Diamond
AIRCRAFT

Service Bulletin No.: DA20-24-02, Rev. 0

Title: DC Generation, (Improved Generator Grounding)

Figure 1 (Ref. DAI Drawing #20-2400-06-01, Rev. b)

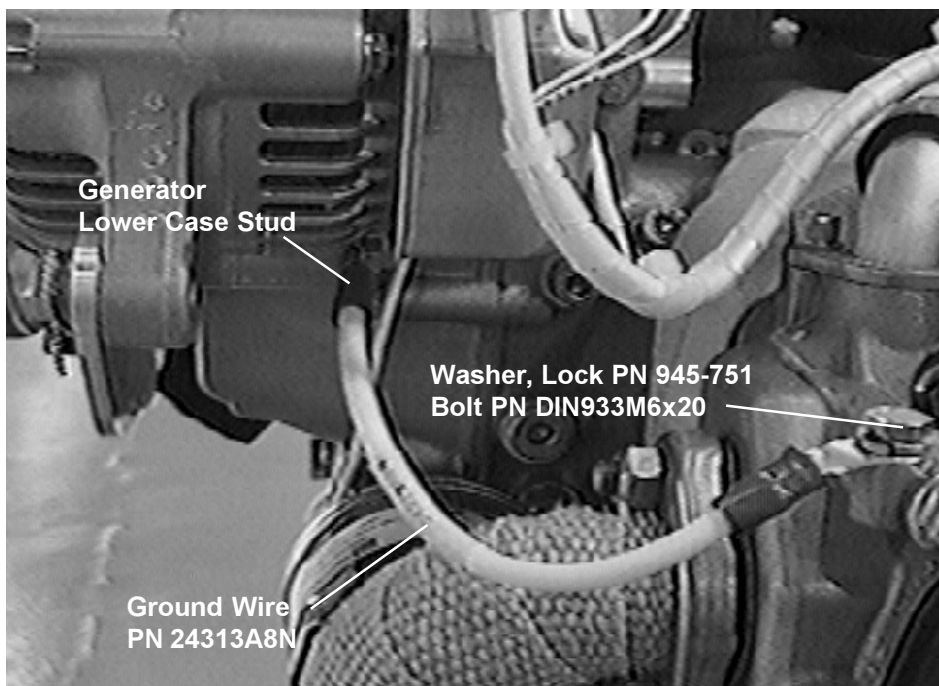
1. **ATA Code:** 2430
2. **Effectivity:** All DA 20 Katana Aircraft up to and including serial number 10045.
3. **General:** The ground return for the generator and generator fail indication is currently supplied through the generator mounting brackets. The addition of a chassis grounding wire from the generator directly to the engine is required to ensure adequate grounding.
4. **Compliance:** Incorporation of this Service Bulletin is highly recommended by Diamond Aircraft and should be accomplished at the operator's earliest opportunity.
5. **Approval:** Engineering data referenced or contained in this bulletin is Transport Canada approved.
6. **Labor:** Approximately 0.5 man hour.
7. **Material:**

- 10.2 Ensure all electrical contacts areas are clean.
 - 10.3 Remove lower case bolt from generator. Place the lower case bolt through the grounding wire ring terminal and re-install the bolt into the generator housing.

- 10.4 Place the supplied bolt and lock washer through the grounding wire ring terminal and install in the # 2 cylinder head casting threaded hole located on the top forward outboard part of the cylinder.

- 10.5 Route the wire clear of the exhaust pipe.
 - 10.6 Ensure the engine compartment is clear of foreign materials and re-install the engine cowlings.
